Appendix L
Public Comments and Responses

Figure 3-19. Dissolved oxygen percent saturation statistics from all river stations from January 2006 through January 2008.

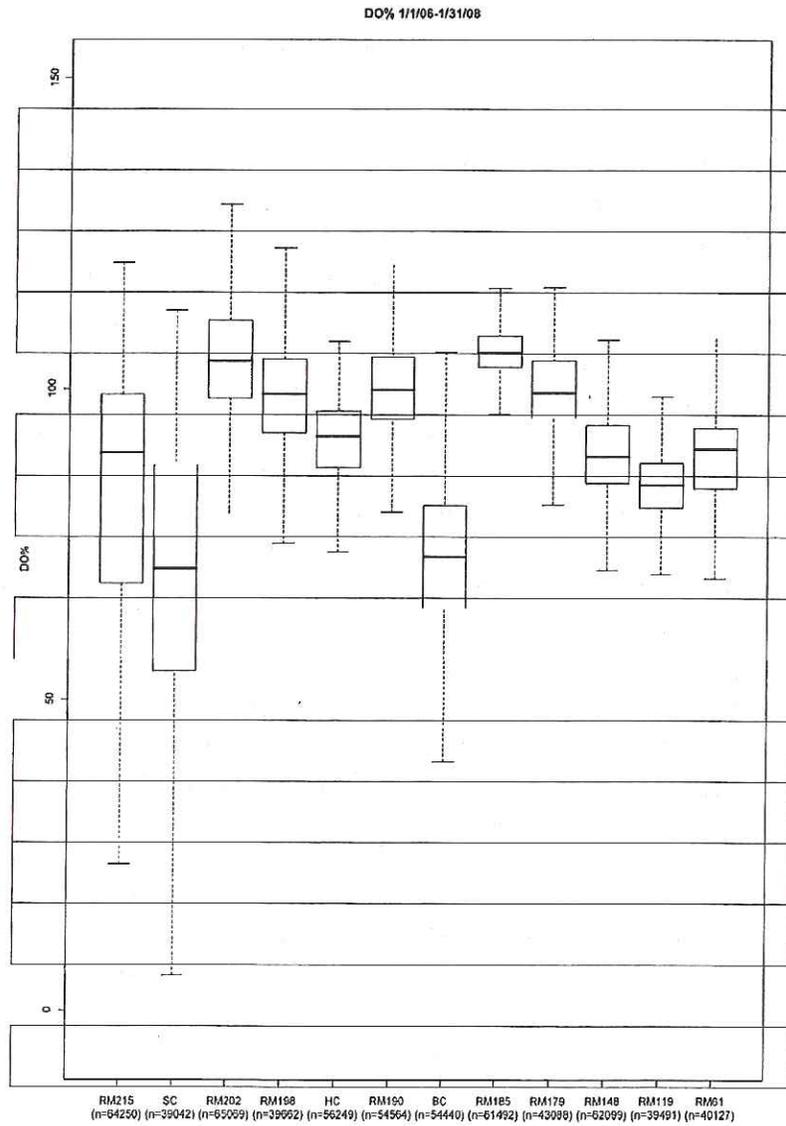
Since dissolved oxygen is so critical, there should be peer reviewed documentation from other rock ramp projects around the country that show dissolved oxygen dynamics will not be impacted by the chosen alternative. Furthermore, that documentation should be in the form of measured data from those projects and not modeled results since this impact is so critical to restoring the river and could impact the viability of each municipal and industrial discharger below Thurmond Dam.

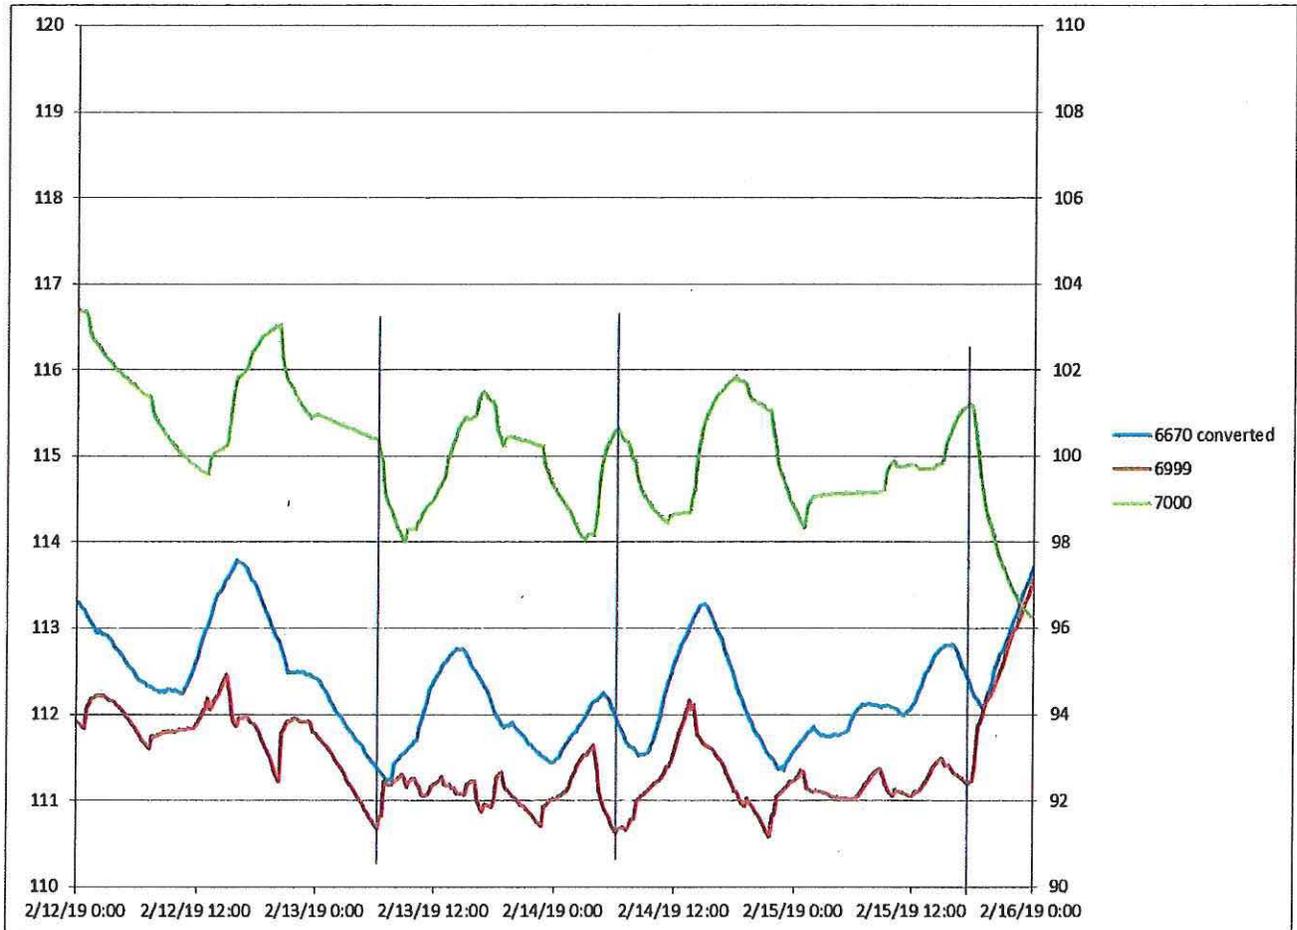
So, the delta between the 6670 and 6999 gauges for the dataset between 2/10/19 and 2/20/19 ranges from 0 ft to nearly 3.5 ft with the lower elevation differences occurring when the dam is adjusted to fill the pool. An adjustment of lowering the pool elevation causes both 6670 and 6999 elevations to change nearly identically (rate of change) while 7000 increases as shown on 2/10/19 at 1630.

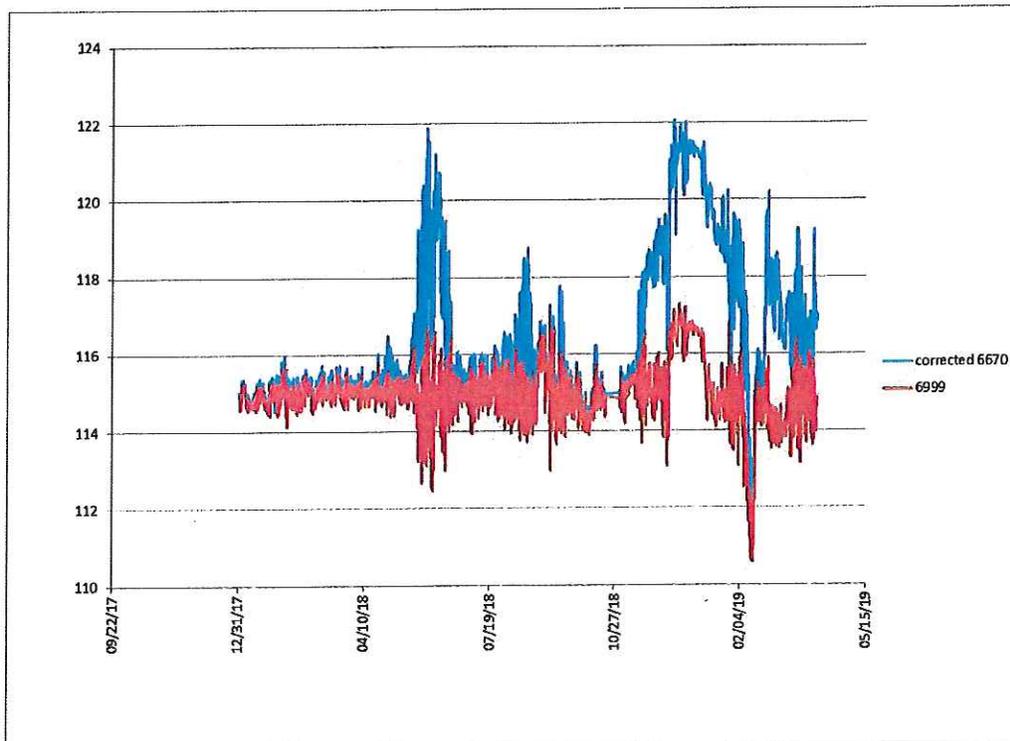
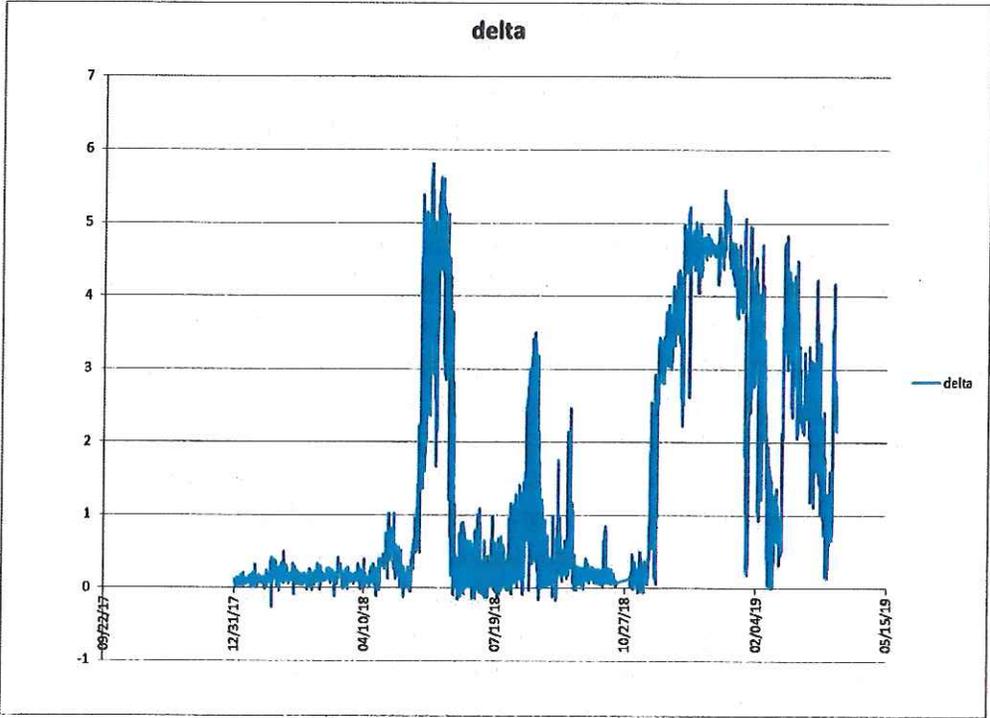
Taking into account a larger dataset, the difference between 6670 and 6999 can be significant as shown in the charts below, a range of -0.26 ft to 5.81 ft. These data show that during flooding periods the largest differences were a result of being able to pass the water through the dam in an effort to keep the pool elevation steady. It is therefore very difficult to determine what the overall impact will be since all gauge data have the impact of the adjustable weir, this includes any modeling efforts that have gone into making decisions about water elevations in the pool. Furthermore, it is necessary to provide alternatives for adaptive management of volume and timing adjustments for Thurmond Dam and Stevens Creek Dam reservoir release schedules once an alternative is chosen. That is, daily pulses shown in these data may have significantly more impact on pool elevation in the absence of the ability to adjust the low-head dam structure at Lock and Dam. It would be better to be able to run a real-world simulation where the overflow weirs at Lock and Dam are held constant while flows from upstream have natural variability. Not sure if this is possible with the current Lock and Dam configurations but this would help make more informed decisions about the correct alternative to choose and the overall impact of changes to Lock and Dam with a fixed weir scenario.

Figure 4: Underwater jetty protruding through water surface following river level drawdown.

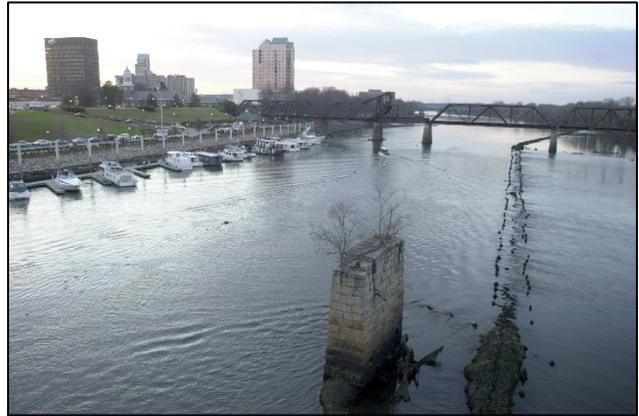
As for navigability within the pool, the lowered water levels of all of the Option (ii) choices will impair or prevent safe navigation of several reaches of the pool. The recommended plan is particularly onerous, in that it purports to keep the functionality of the pool, yet dangerously exposes boat traffic to underwater obstructions that heretofore have not come into play. A particular safety issue would be newly created along the structure known as Gardner’s Bar training wall or jetty, which extends for about one

Figure 9: National Wetland Inventory Map for New Savannah Bluff Lock and Dam
2.2.5 Terrestrial Resources and Wildlife

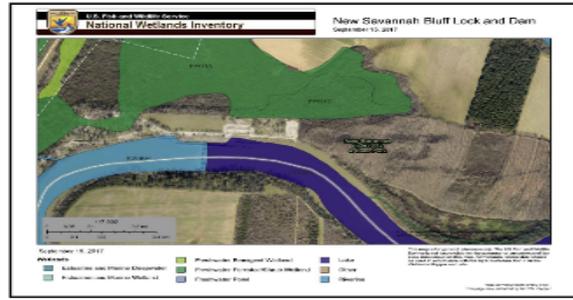
- Impacts to wetlands adjacent to project site – PF01A and PFQ1C on Figure 9, and (potentially) others not identified - could not only be impacted by the lowering of the water upstream of the pool, but would also likely be further impacted by alternatives that include lowering of NSBLD Park. Excavation of the so-called wetlands bench will increase the hydraulic head differential and thereby tend to drain the wetlands identified in the NWI Map and other potential wetland areas located north easterly of the site.

Figure 2
Non-Exceedance Curve from Draft Report

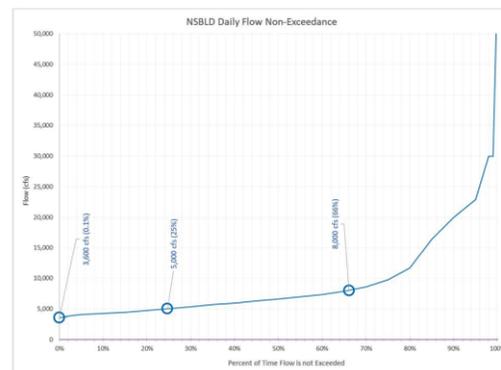
The Draft Report often references and reports pool elevations based upon a normal flow rate of 5,000 cfs. From the Draft Report: *"The flow used to evaluate the project impacts, with the exception of impacts to water supply intakes, is 5,000 cfs, the low average of the normal flow."* It is not clear why this flow rate was selected and we are not aware of a definition for *"the low average of the normal flow"*. However, flows lower than this occur over 25% of the time. This can be observed on Figure 7 of the Draft Report. **One-quarter of the time is very significant.** It can also be observed on this figure that the curve is quite "flat" from 3,600 (0.1%) to 8,000 cfs (66%). This again indicates that flows within this range occur much (66%) of the time and that there is a steep drop-off after 3,600 cfs.

*Figure 6
Velocity Output Figure of Alternative 2-6d at 8,000 cfs*

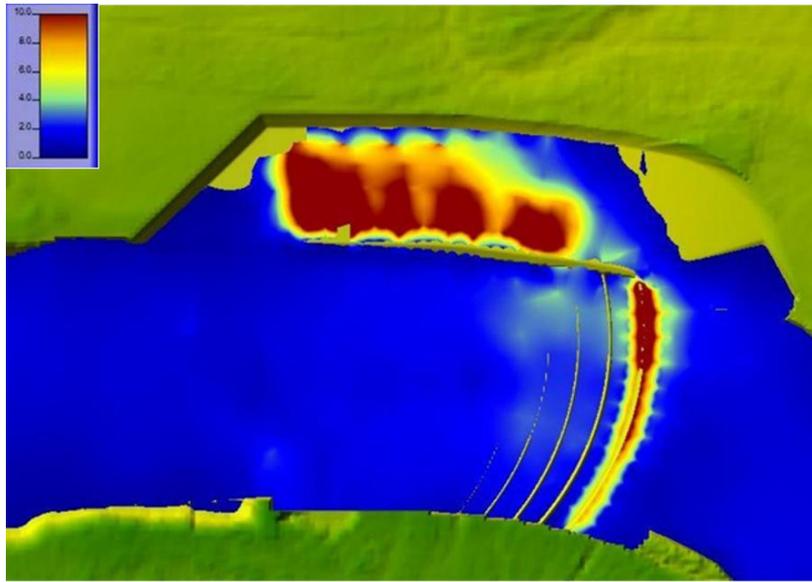
Figure 6 is a velocity output of the HEC-RAS model for Alternative 2-6d. The model provides estimation of the crest accurately because the geometry of the crest has a substantial impact on the water surface elevations predicted for the various alternatives with a rock ramp.

Adaptations to the crests of the alternatives with a full-river width rock ramp may be necessary to create effective passage of target fish species. These adaptations are likely to require changes in the alternatives, lower upstream pool elevations more than currently predicted, cause other impacts, and ultimately influence a well-informed selection process.

*Figure 7
Observed Water Surfaces during the February Drawdown*

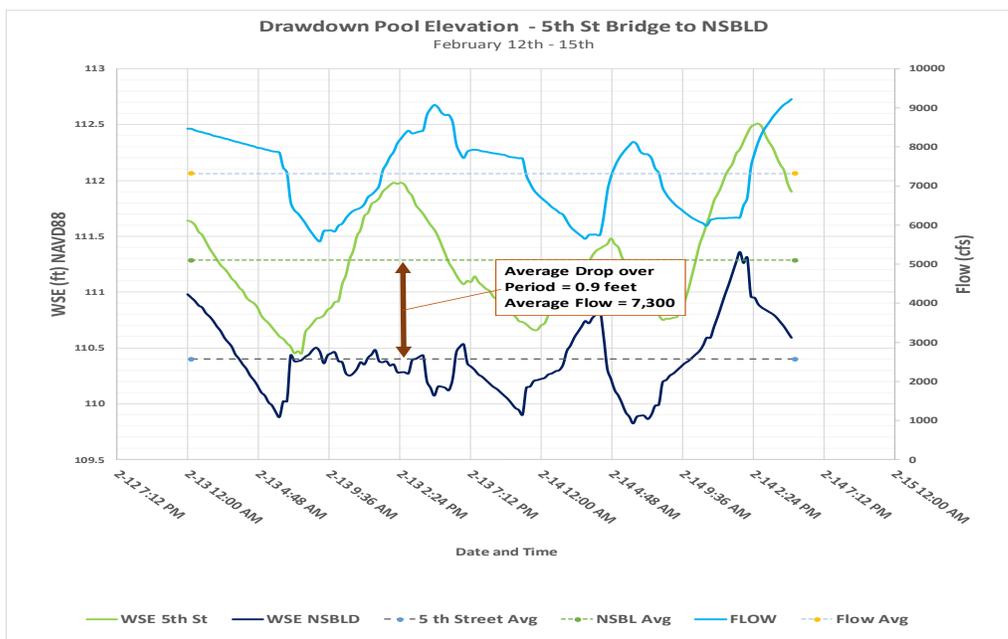
Verification of the “riverine model for depth attenuation within the pool” has not been received as of this date. To review the accuracy of the HEC-RAS hydraulic modeling, we have reviewed gage data just upstream of the NSBLD and at 5th Street. Results of this review are shown in Figure 7. Figure 7 includes just a portion of the gage data during the drawdown. An extended plot of the gage data shows higher fluctuations in the flows and water surface elevations at the gages before and after the period shown from 2/13/2019 to 2/14/2019. Even during this period, there are fluctuations in flow and water surface elevations, however review of the gage data in other ways showed similar results. While there is error in applying steady state results to unsteady conditions and in how the gage data is interpreted, this initial review should be useful in interpreting impacts at this juncture and in driving home the needs for further investigation and to determine if further reconfiguration or redevelopment of the alternatives is prudent.

The average flow during this period was about 7,300 cfs. The average pool elevation just upstream of the NSBLD was 110.4 (NAVD88) and the average elevation was 111.3 (NAVD88) at the 5th Street Bridge. These flows and surface water elevations are shown on Figure 7.

Figure 9: National Wetland Inventory Map for New Savannah Bluff Lock and Dam
2.2.5 Terrestrial Resources and Wildlife

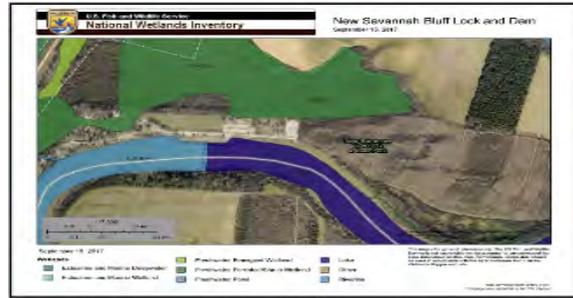
- Impacts to wetlands adjacent to project site – PF01A and PFQ1C on Figure 9, and (potentially) others not identified - could not only be impacted by the lowering of the water upstream of the pool, but would also likely be further impacted by alternatives that include lowering of NSBLD Park. Excavation of the so-called wetlands bench will increase the hydraulic head differential and thereby tend to drain the wetlands identified in the NWI Map and other potential wetland areas located north easterly of the site.

Figure 2
Non-Exceedance Curve from Draft Report

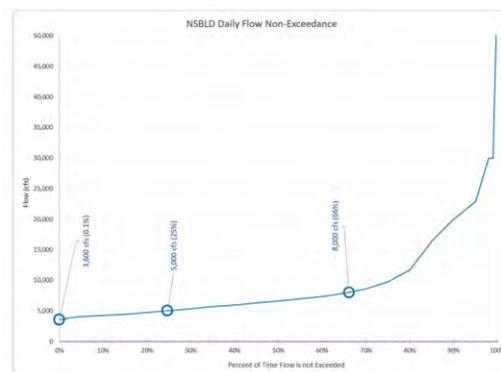
The Draft Report often references and reports pool elevations based upon a normal flow rate of 5,000 cfs. From the Draft Report: *"The flow used to evaluate the project impacts, with the exception of impacts to water supply intakes, is 5,000 cfs, the low average of the normal flow."* It is not clear why this flow rate was selected and we are not aware of a definition for *"the low average of the normal flow"*. However, flows lower than this occur over 25% of the time. This can be observed on Figure 7 of the Draft Report. **One-quarter of the time is very significant.** It can also be observed on this figure that the curve is quite "flat" from 3,600 (0.1%) to 8,000 cfs (66%). This again indicates that flows within this range occur much (66%) of the time and that there is a steep drop-off after 3,600 cfs.

*Figure 5
Crest Section of the Rock Ramp (Alternative 2-6d)*

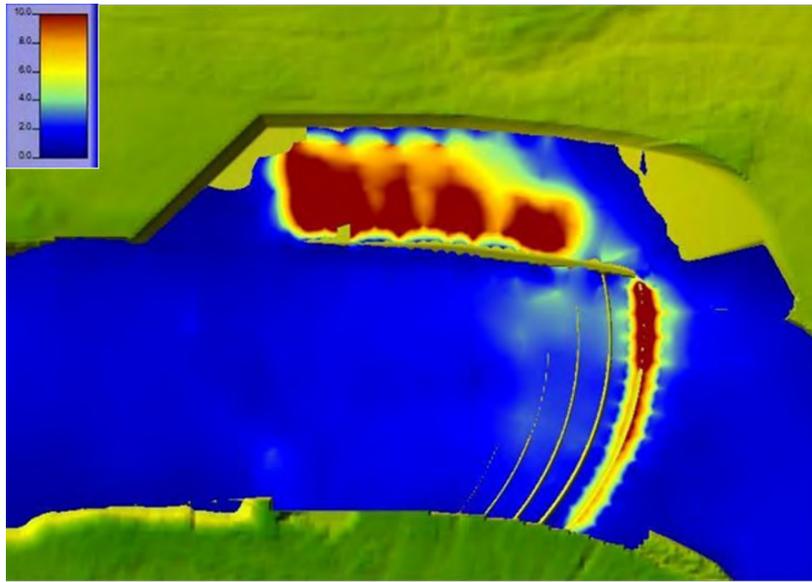
Review of the modeling that is used to predicted water surface elevations just upstream of the NSBLD for the alternatives was not reviewed in detail. At the proposed grade of 2% and the roughness coefficients provided, it is likely that the flow will be in a supercritical state, or at least go through critical depth at the crest of the rock ramp. Therefore, of primary concern is the configuration of the crest of the rock ramp. Figure 5 is a cross-section of the rock ramp fish passage of alternative 2-6d from the Draft Report. All the rock ramps in the various alternatives with rock ramps appear to be of a similar configuration.

Figure 7
Observed Water Surfaces during the February Drawdown

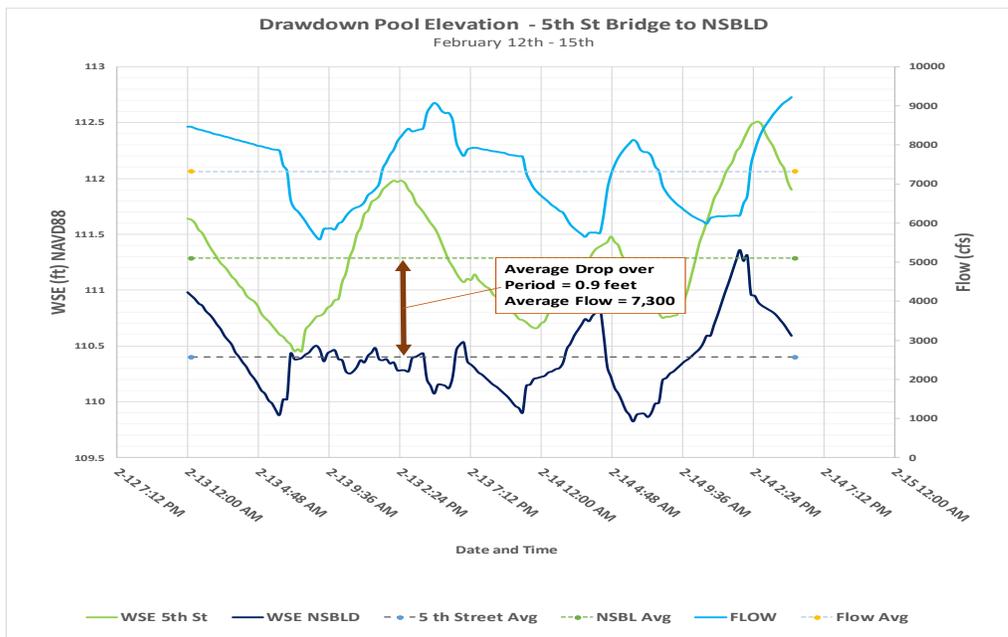
Verification of the “riverine model for depth attenuation within the pool” has not been received as of this date. To review the accuracy of the HEC-RAS hydraulic modeling, we have reviewed gage data just upstream of the NSBLD and at 5th Street. Results of this review are shown in Figure 7. Figure 7 includes just a portion of the gage data during the drawdown. An extended plot of the gage data shows higher fluctuations in the flows and water surface elevations at the gages before and after the period shown from 2/13/2019 to 2/14/2019. Even during this period, there are fluctuations in flow and water surface elevations, however review of the gage data in other ways showed similar results. While there is error in applying steady state results to unsteady conditions and in how the gage data is interpreted, this initial review should be useful in interpreting impacts at this juncture and in driving home the needs for further investigation and to determine if further reconfiguration or redevelopment of the alternatives is prudent.

The average flow during this period was about 7,300 cfs. The average pool elevation just upstream of the NSBLD was 110.4 (NAVD88) and the average elevation was 111.3 (NAVD88) at the 5th Street Bridge. These flows and surface water elevations are shown on Figure 7.
